ADDENDUM NUMBER: 5
PROJECT: **UNC Charlotte Residence Hall Phase XIV - Early Site Packages**

DATE: **March 4, 2015**
OWNER: **UNC Charlotte**
ARCHITECT: **FWA Group**

Early Site Package Pre-Bid RFI #1

Early Site Package Pre-Bid RFI #2

**SITE WALL
PLAN**

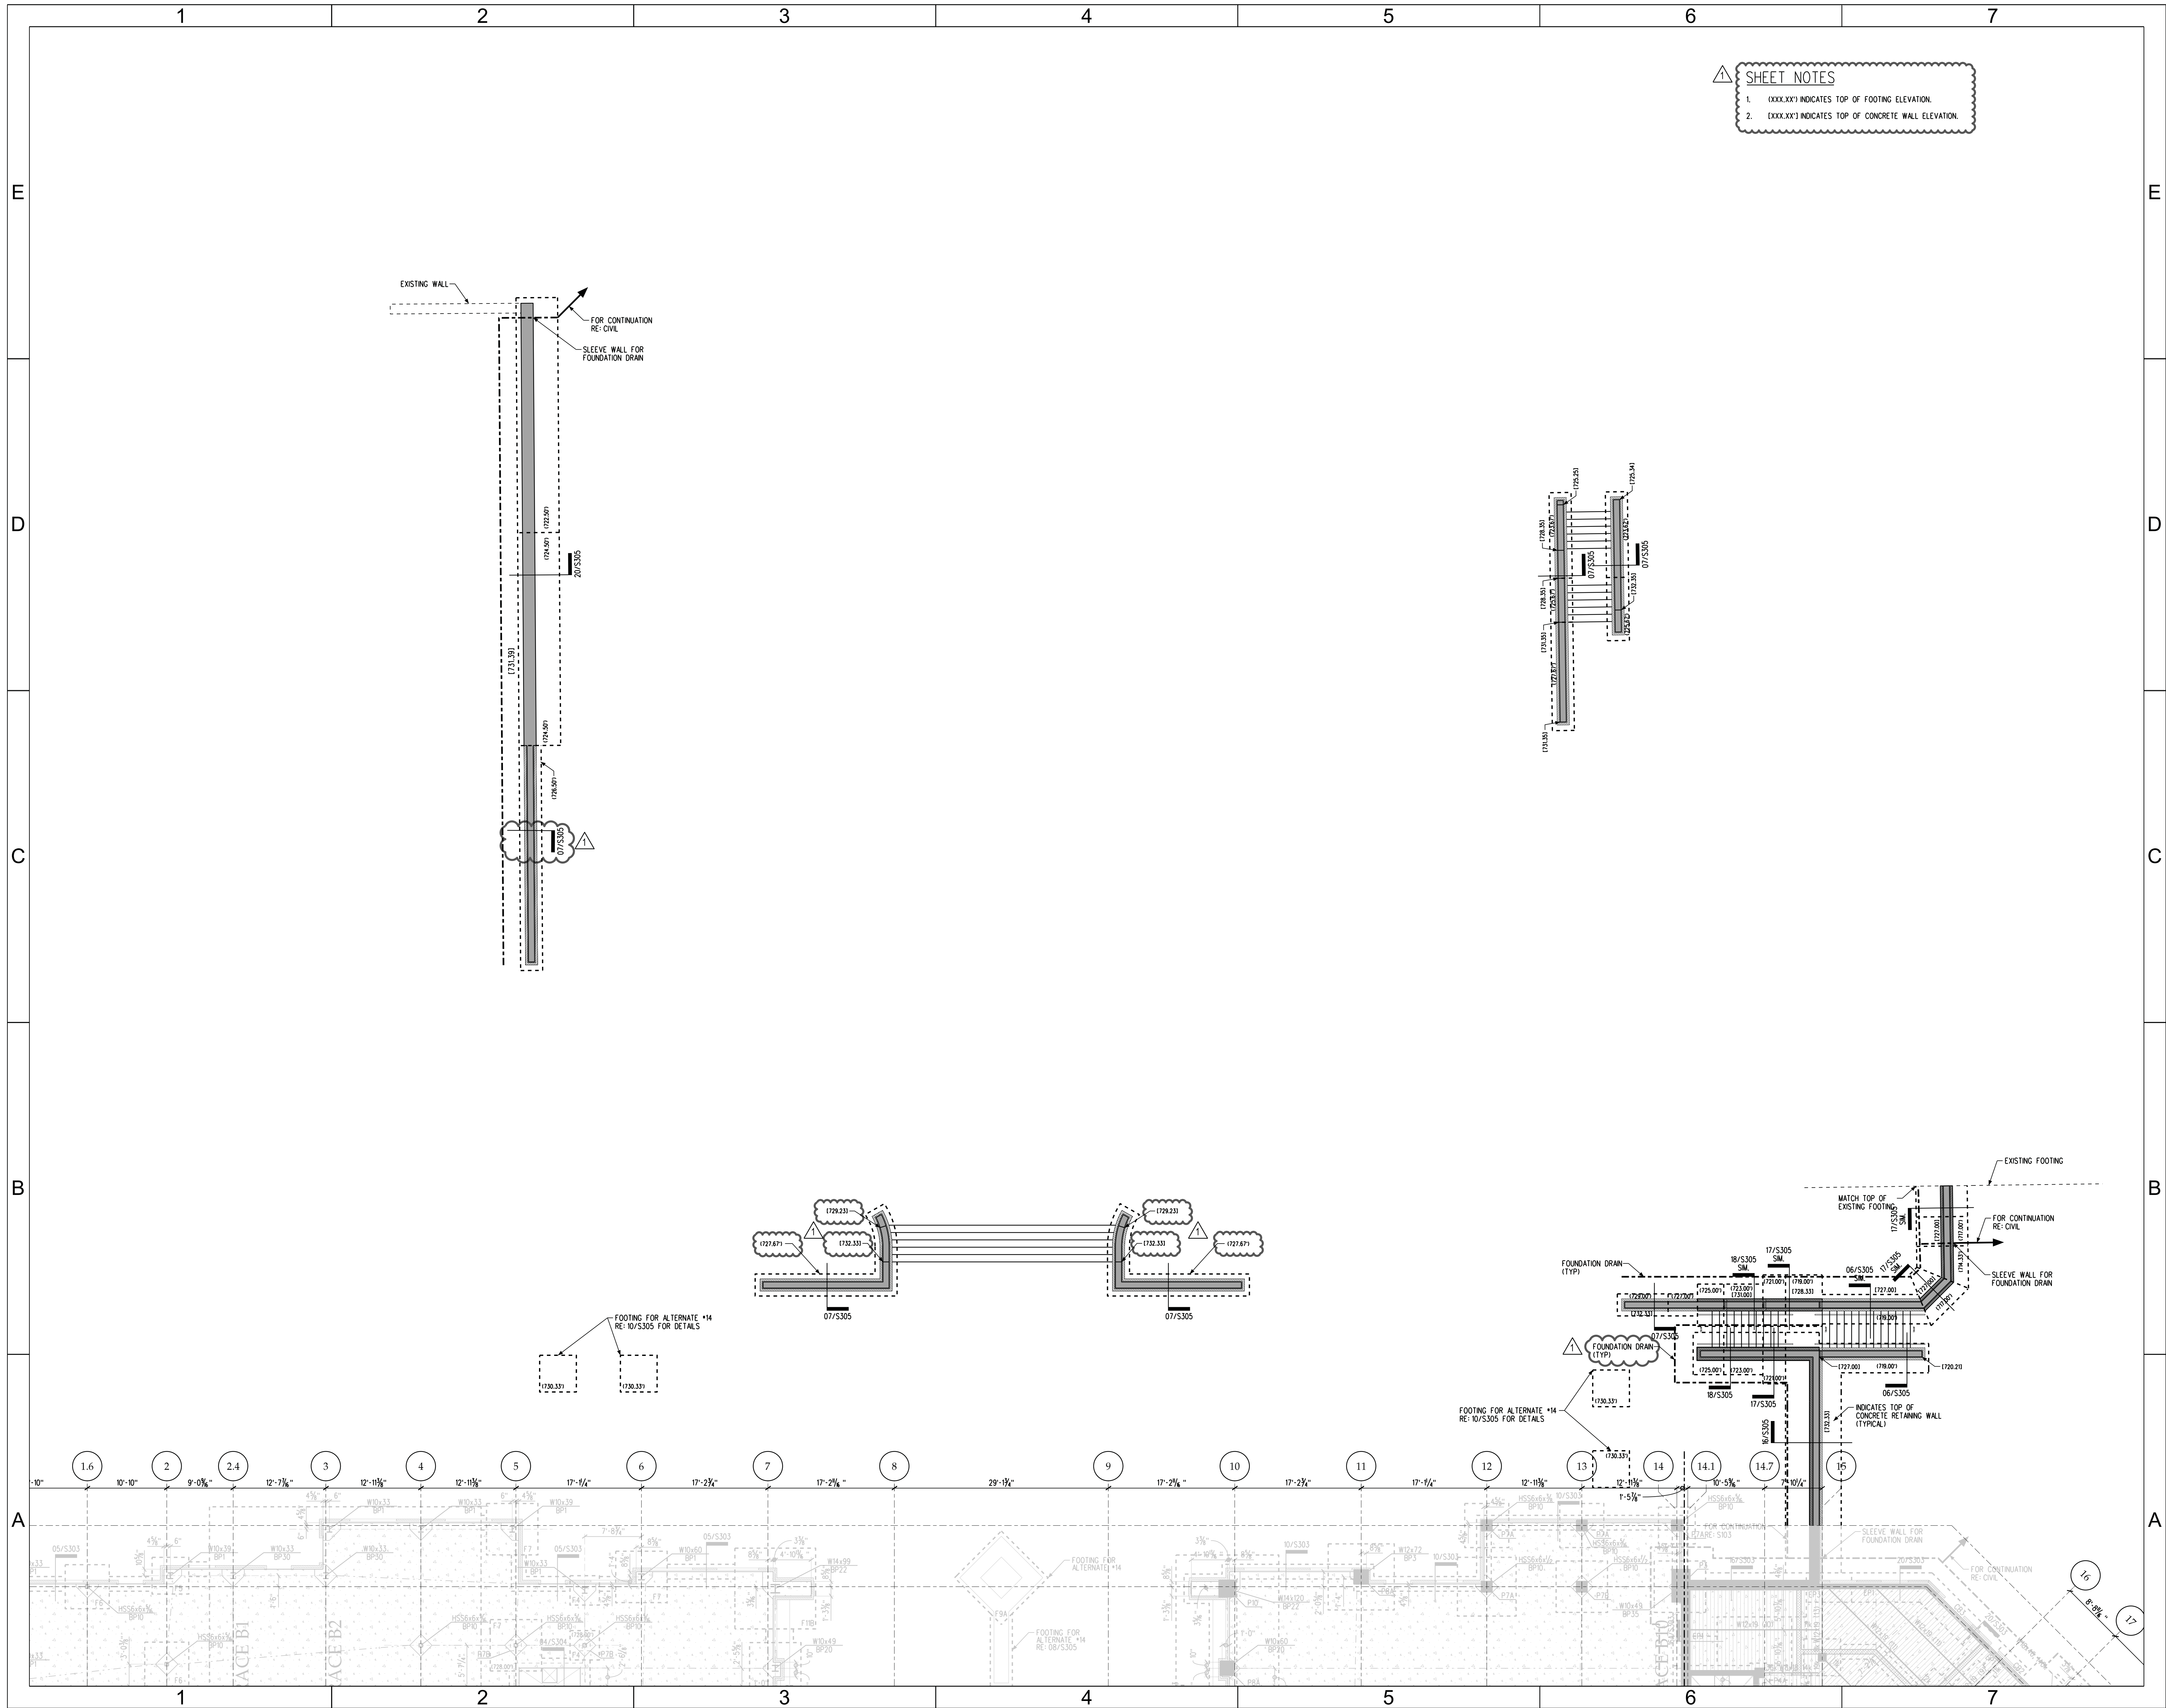
Answer:	Rodgers Response: Per RFI#2 answer above, BP02A is responsible for this backfill.
7	Please provide top of footing and top of wall at the entry steps closest to the South Building breezeway (plan south S103).

8	BP03C bid package scope includes all below grade waterproofing. BP02A scope item B13 includes foundation drainage and drain board outside the building footprint. Please verify that BP03C will provide drain board as part of waterproofing systems at the basement foundation walls per details A500 with the exception of the drain board in detail A4/A500 which is shown on the exterior side of the masonry and therefore would be provided by 02A.

Answer:	BSDE Response: This information has been added to the drawings. See FWA Addendum #02.

Answer:	BSDE Response: Primary Foundation drainage plans are shown on sheet S102-N & S102-S. Note that civil drawing C5.10 must be referred to for tie ins. Also note that foundation drainage is called for behind site walls on sheet S103
43	For Bid Package 02A, do we include all 4"/6"/8" Sanitary Sewer lines in bid breakdown 8.01? Or would you like to add more line items?

**2ND FLOOR
SOUTH
FRAMING PLAN**

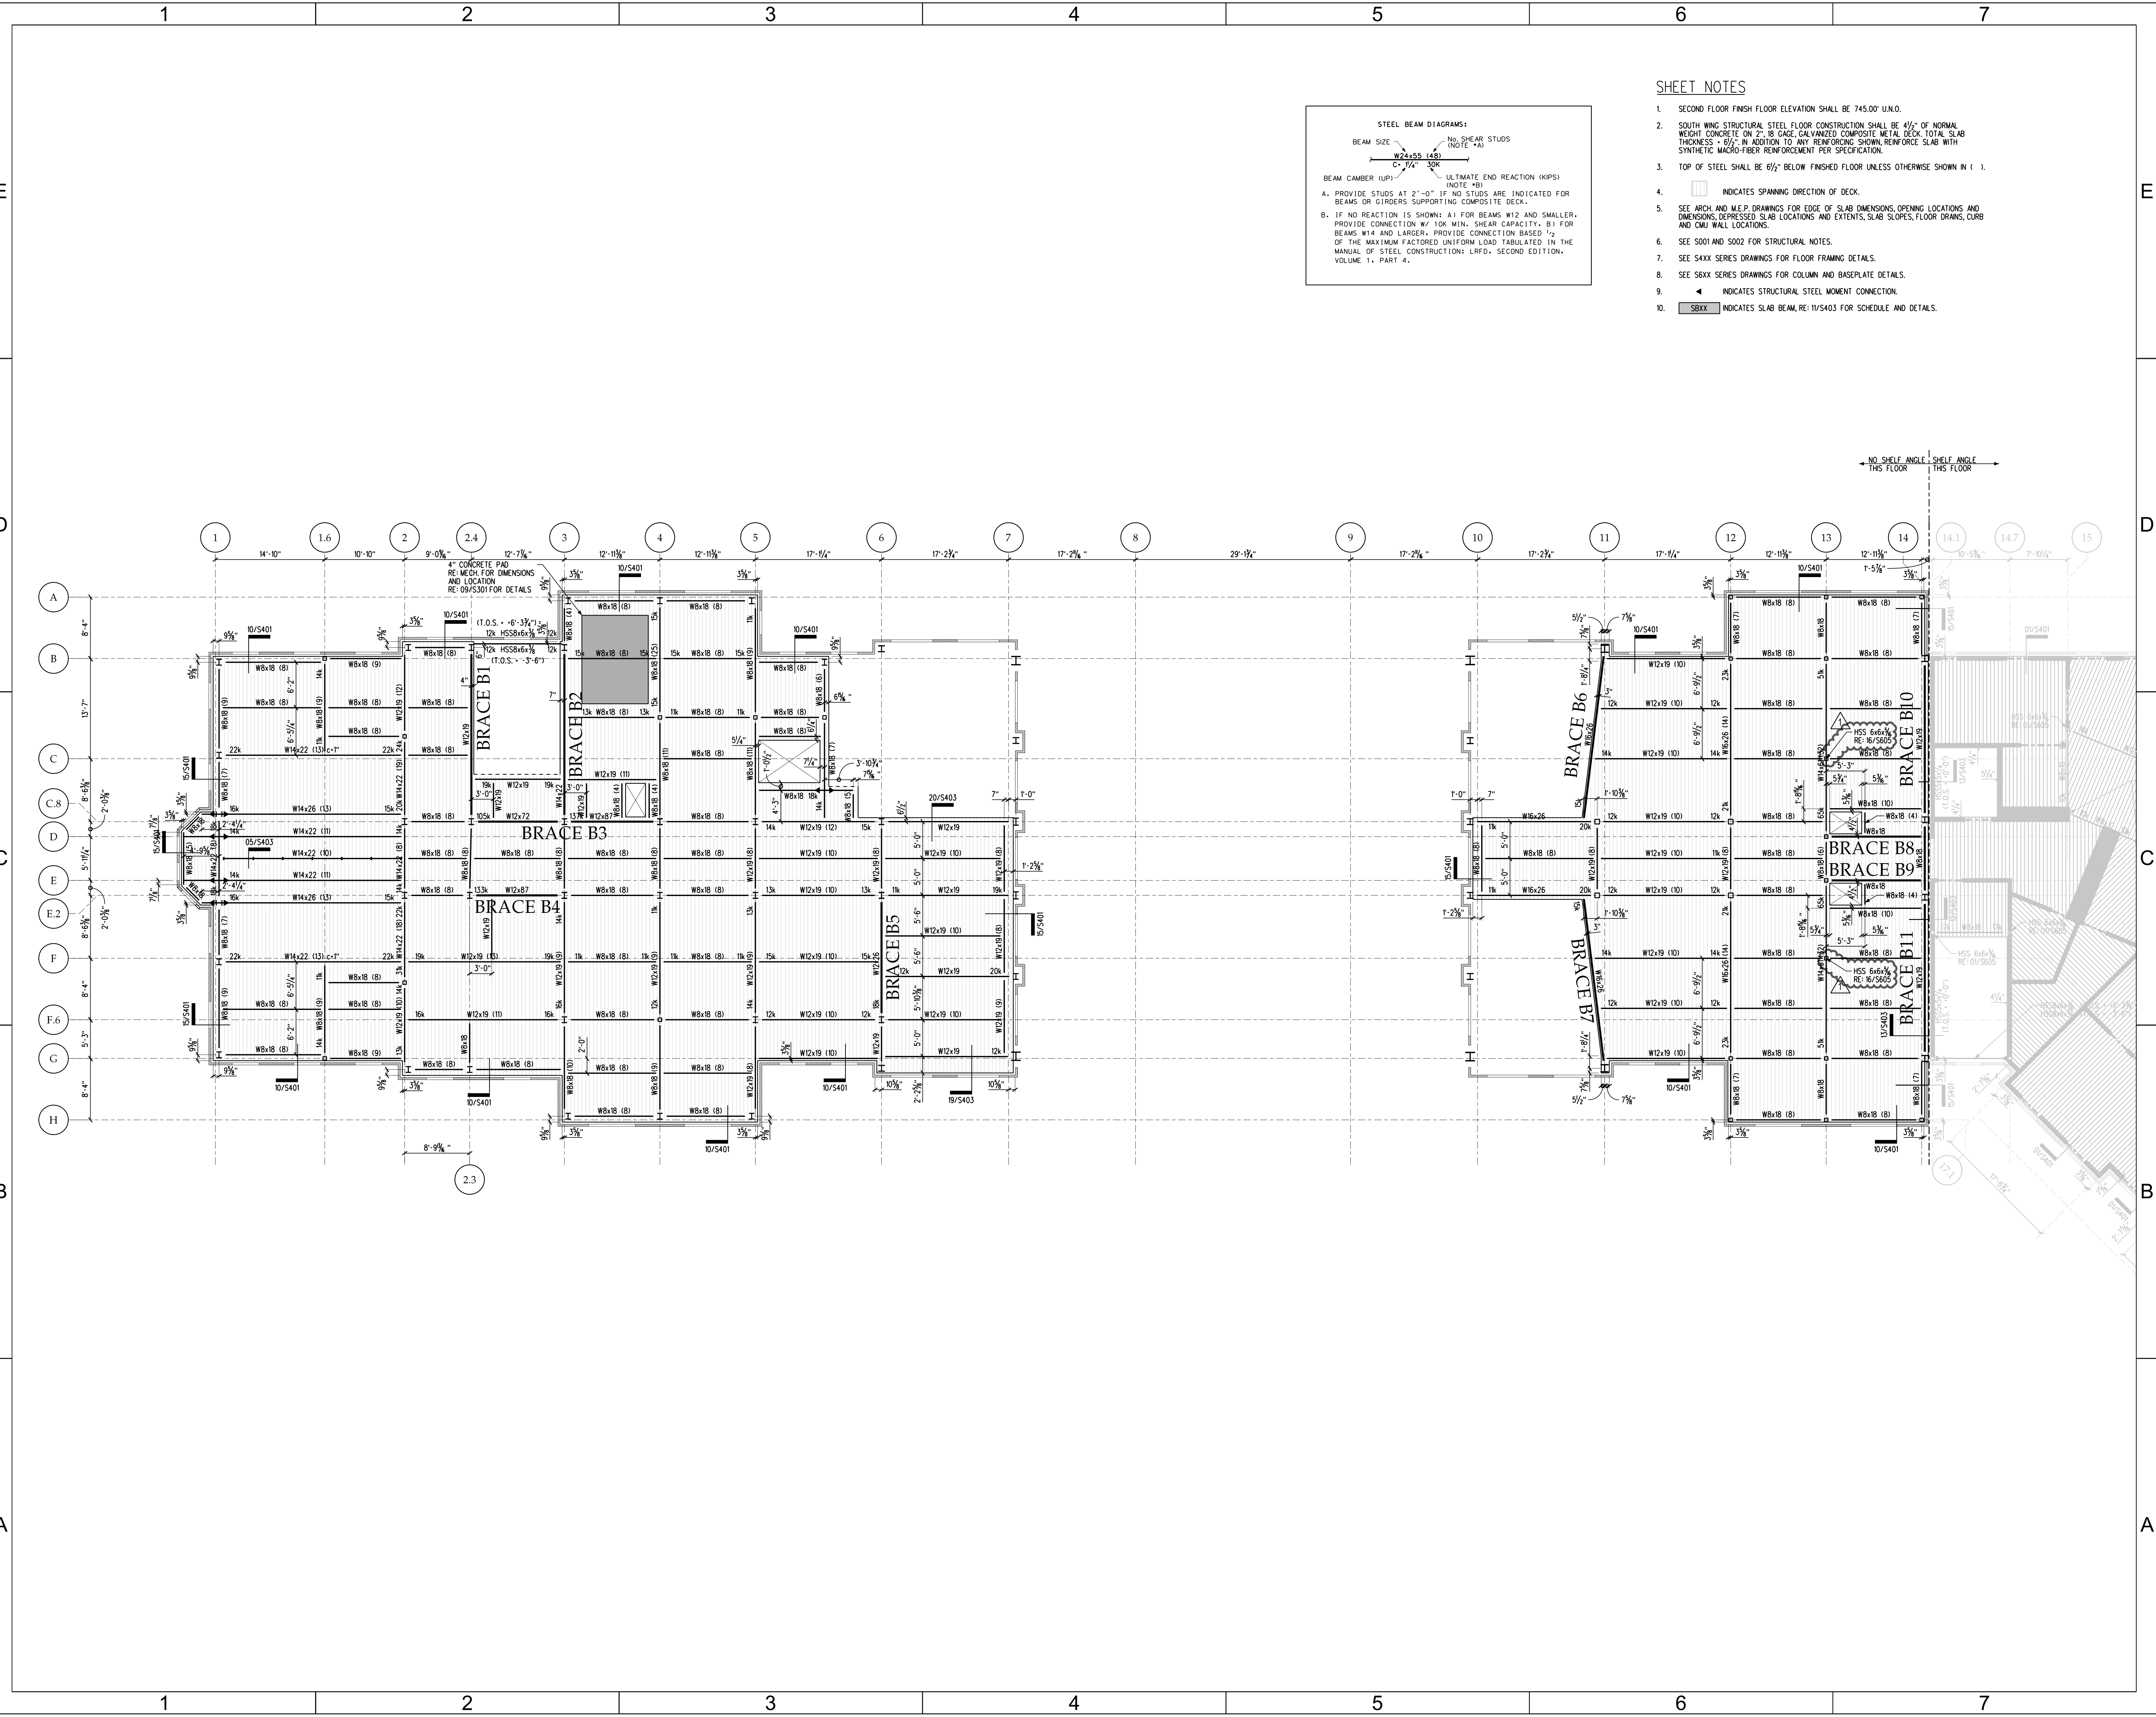
Answer:	FWA RESPONSE: No additional structural steel is required for the overhead doors.
4	There are no posts shown on drawing S202-S at grids C and F along 13 to support beams for the 3rd floor, drawing S203-S. Please clarify.

Answer:	BSDE RESPONSE: As of Addendum #2 (dated 2015-02-05) these posts have been shown.
5	Regarding the structural steel scope, do the metal deck shop drawings need to be signed and sealed by an engineer?
